Novi Town Center Building F Demo SP 10-26

PLANNING REVIEW

Novi Town Center Bldg. F Demo

SP #10-26

DATE: 03-30-10
 SCALE: 1"=30'
 SHEET: C6.1
 JOB: 17844 US

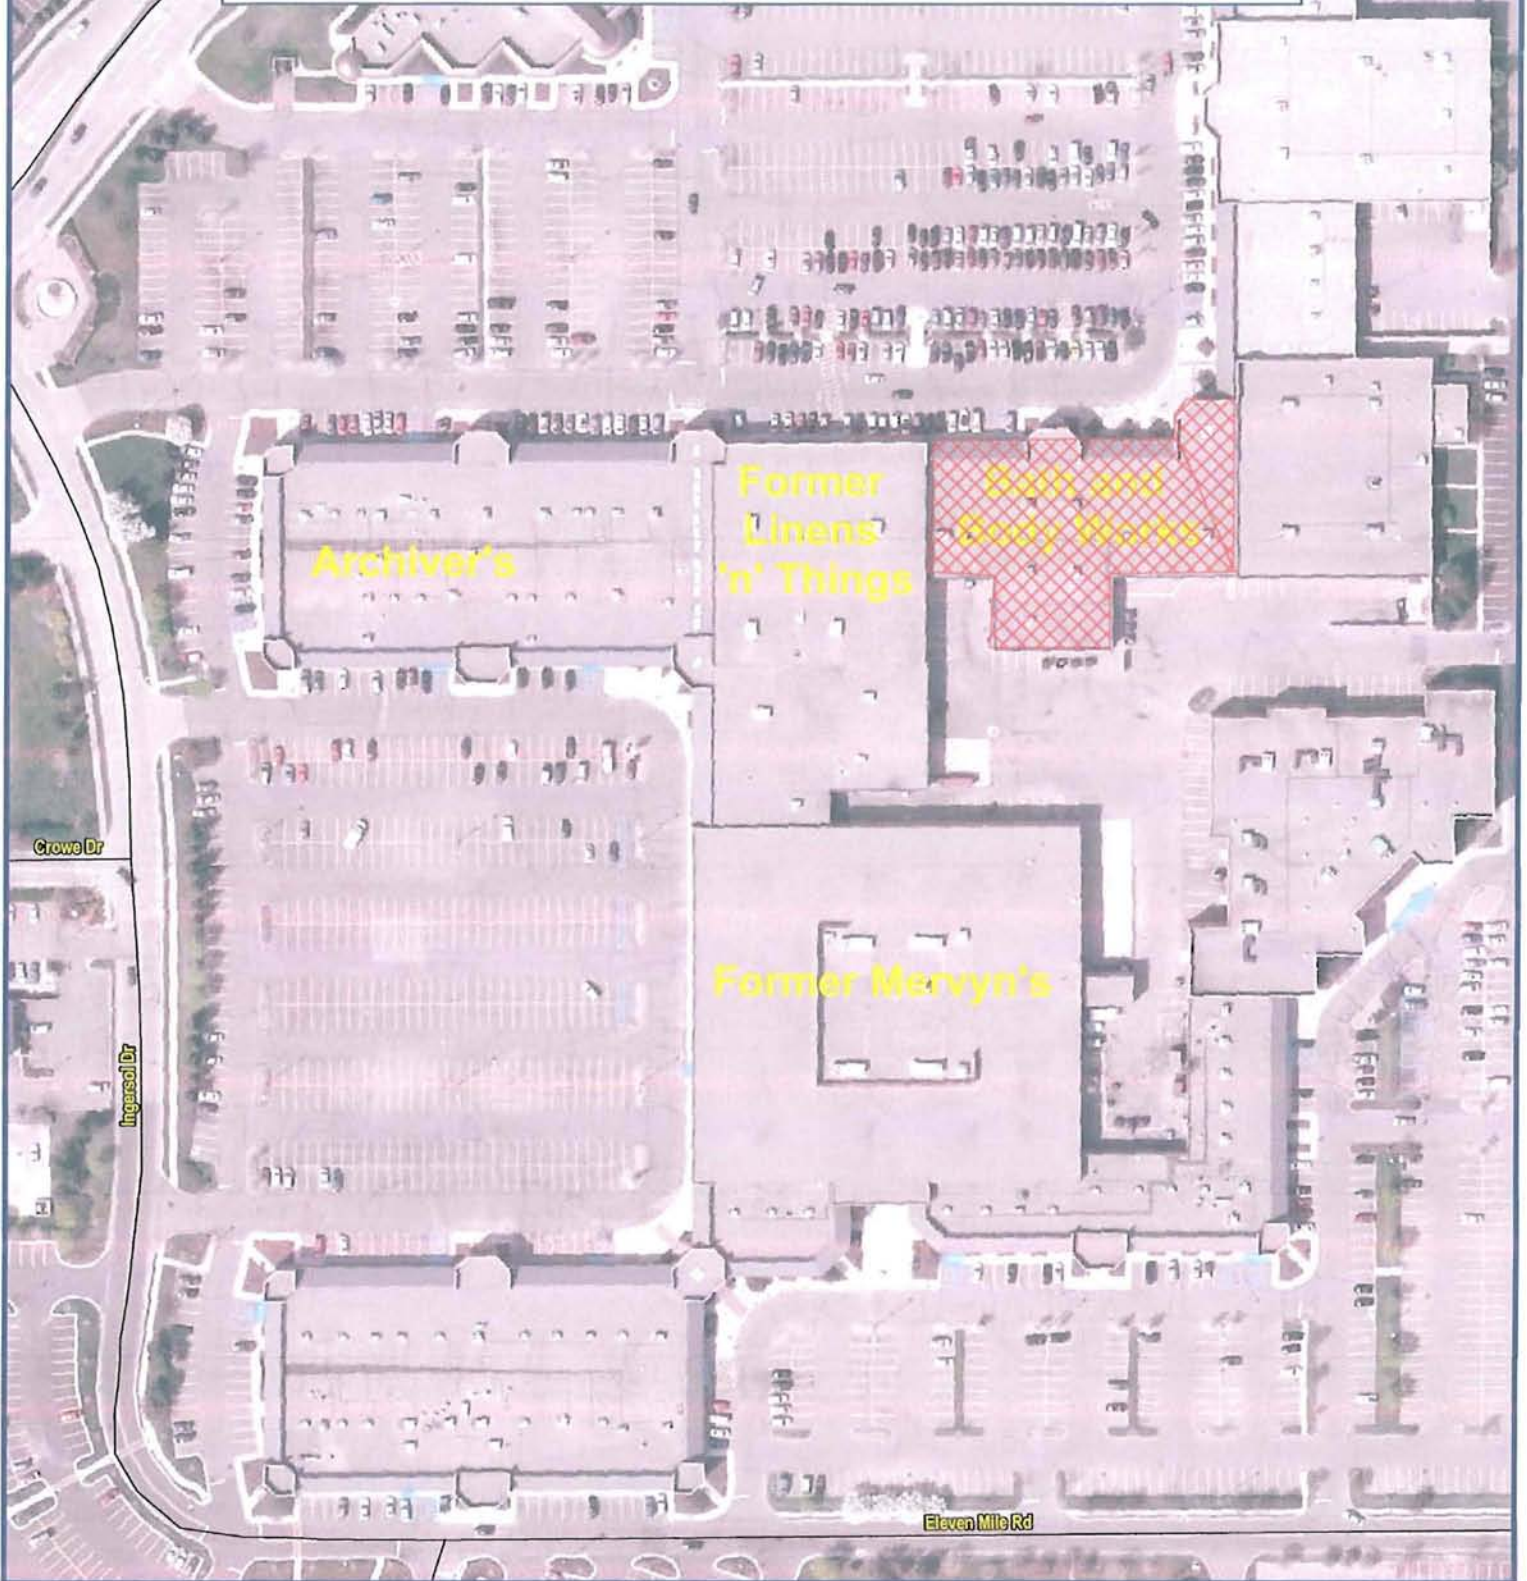
2. Parking adjacent to Building D: **Remove all parking adjacent to Building D sidewalk until such time as a Traffic Impact Study demonstrates that parking in that location will operate safely and effectively.**

3. Building E Loading Area: There does not appear to be sufficient screening for the loading area southeast of the demolition area. **The applicant should extend the proposed fence along the entire length of the landscape area and clearly show all existing loading and parking spaces surrounding Buildings E and K.**

16. Curbing and walks adjacent to the end of 17-foot stalls shall be reduced to 4-inches high, rather than the standard 6-inch height to be provided adjacent to 19-foot stalls. Provide additional details as appropriate and label all curbing heights on the plan.

3. We will discuss and come to a resolution regarding the requirement of extending the 6 ft. tall wooden fence to run the entire length of the adjacent loading area during the Planning Commission Meeting. We will revise the plans to indicate the load areas and existing parking associated with buildings E and K.

15. Top of Curb / Top of walk grades will be added.
16. All curbs adjacent to head in parking are 4" curb, plans will be revised as per above comment.
17. A letter will be prepared and submitted with the revised plans outlining all changes. A statement will be included that all changes to the plans have been identified in said letter.

PROPOSED EAST ELEVATION
SCALE 1/8" = 1'-0"

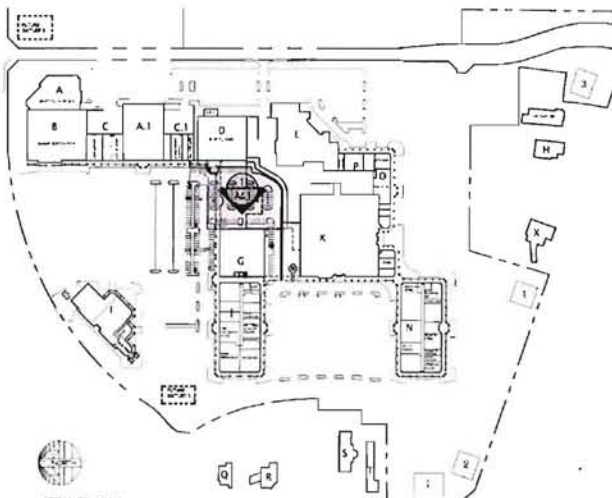
As shown above the proposed materials are in full compliance with the Façade chart, with the exception of Section 2520, Footnote 3, which states that Standing Seam Metal must be "100 percent copper or copper bearing paint in the TC and TC-1 districts."

With respect to the use of non-copper colored standing seam metal awnings, the proposed design is consistent with other recent facade upgrades for which the Planning Commission has previously granted Section 9 waivers for the use of green, blue and black standing seam metal. The proposed design is in full compliance with Section 1602.9 of the Ordinance which requires that materials used in the TC and TC-1 districts be "primarily brick or stone".

- Item No. 4: The Section 9 waiver will be requested for the metal awning color, as has been requested and granted on previous Phases of the Shopping Center upgrades and remodeling.
- Item No. 6: The lamp type for the Sun Valley light fixture will be a 70-watt metal halide as specified on Sheet SE0.2 of the Site Plan Submittal.

- The Section 9 waiver will be requested for the metal awning color, as has been requested and granted on previous Phases of the Shopping Center upgrades and remodeling.
- The screening of the newly exposed service court for Building "E" and "K" will be discussed and resolved at the June 23rd Planning Commission Meeting.
